UNITED STATES PATENT AND TRADEMARK OFFICE

10/516,528

Office Action Summary	Application No. 10/516,528	Applicant(s) BEDEN ET AL.	
	Examiner Mr. Terry K. Cecil	Art Unit 1723

DETAILED ACTION

FIG. 7

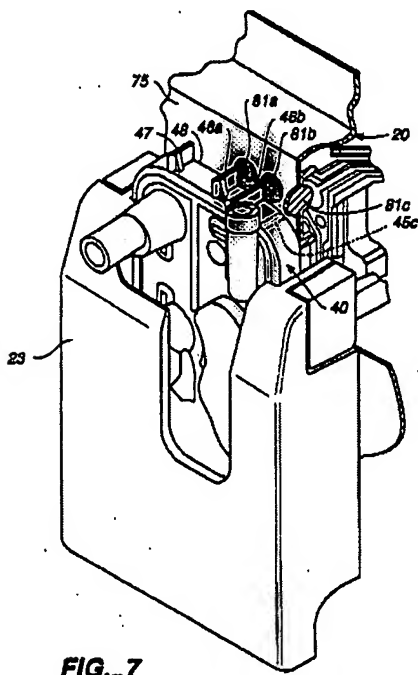
Regarding claims 1 and 3, Pastrone teaches a liquid treatment machine 20 including cassettes (30, 40, 50, 60) for different applications inserted therein. The cassettes have a rigid body (131, 133) and a foil (elastomeric member 133). The fitted chambers and passages of the cassette are best shown in figures 2-4 of U.S. Patent No. 4,927,411, incorporated by reference into Pastrone (col. 5, line 1-9). It is noted that it is the examiner's interpretation of claim 1 that only 1 cassette is required by the claim language (the recitation of "cassettes" is part of

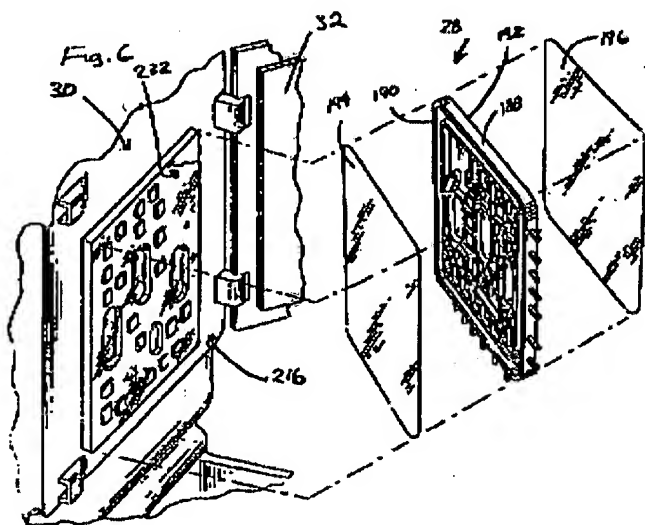
shapes (i.e. different interfacing configurations) resulting from the respective ID flag configurations.
